**AMENDMENT NO. 1 JANUARY 2014
TO
IS 15139 : 2002 AUTOMOTIVE VEHICLES — SAFETY
BELT ANCHORAGES — SPECIFICATION**

FIG.3 TRACTION DEVICE

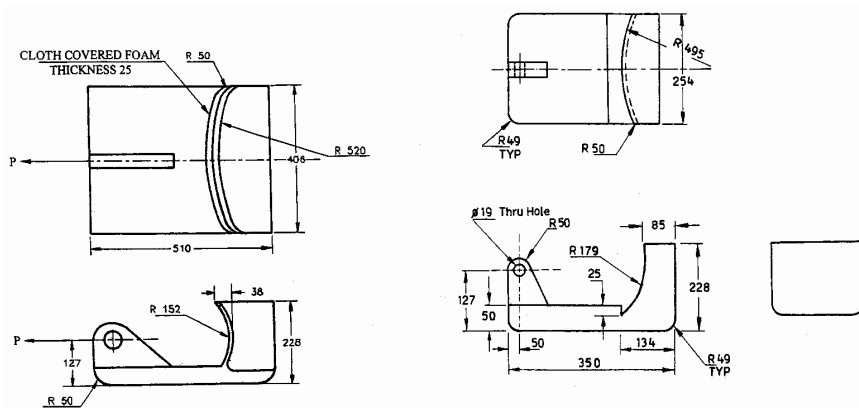
(Page 9, Fig. 3) — Substitute the following for the existing figure:
